TOWN OF NEW WINDSOR	GENERAL	. RECEIPT	
	555 Union Avenue New Windsor, NY 12550		March	- 3L 1994
	Received of Thomas Y	Helen E	vans	\$ 50,00
	fyty 0% w -			DOLLARS
	For flamma B	oand App	elication # 9	74-8
	FUND CODE CIZ-4 402	AMOUNT 50.00	By Dorolly	W. Hansen
			Town (Clark Title
	« WILLIAMSON LAW BOOK CO., VICTOR, N.Y. 14564			Title
	P lanning Board Town Hall		NO. <u>94</u>	-8
	555 Union Ave. New Windsor, N.Y. 1		, ,	.19 <i>.94</i>
		ROM Thomas	Evans	NOTE THE PROPERTY OF THE PROPE

THOMAS EVANS SUBDIVISION

NEW WINDSOR PLANNING BOARD NO. 94-8

EVANS MINOR SUBDIVISION

REV. MAY 3, 1994 REV. MAY 11. 1994 REV. MAY 20. 1994 Sheet 2 of 2

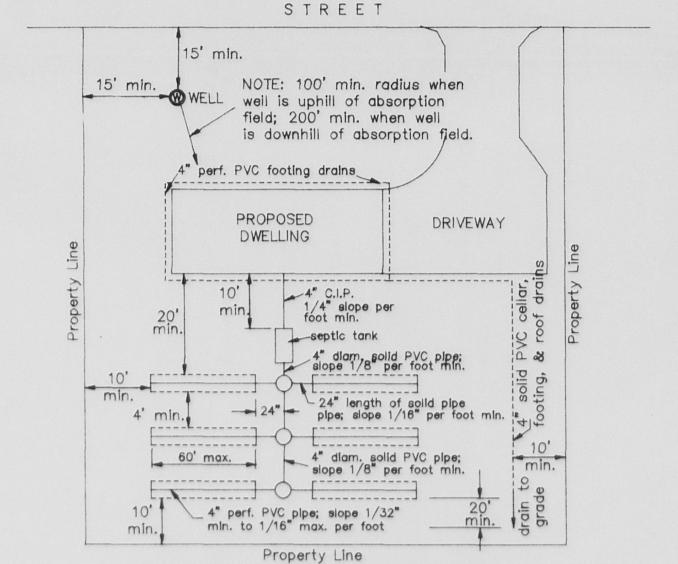
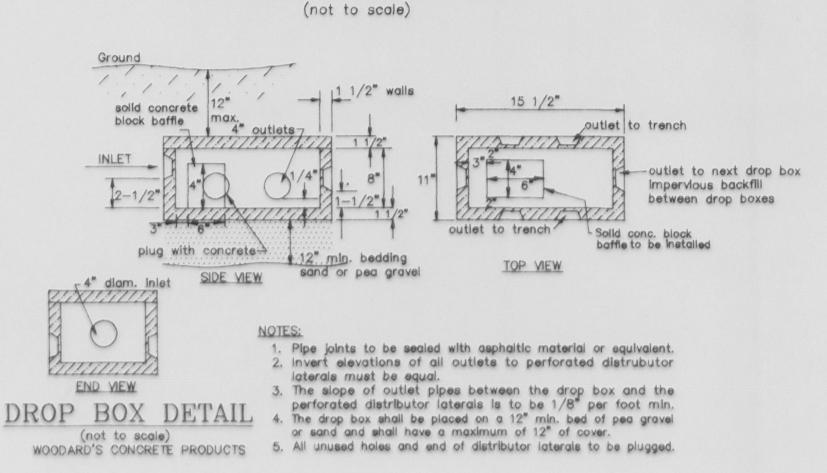
- 2. The Applicant has provided some additional information with regard to the topography of the site. It is questioned whether these contours are based on a field survey or are interpolated U.S.G.S. contours.
- 3. With regard to the sanitary disposal systems, the plan now includes a design for the two (2) new lots, with deep test and percolation information provided on Sheet 2.

The sanitary design data appears acceptable; however, it should be noted that Lot 1 is restricted to three-bedrooms maximum for the residence. The Board should also note that these percolation tests and deep tests were not witnessed by a representative of the Town.
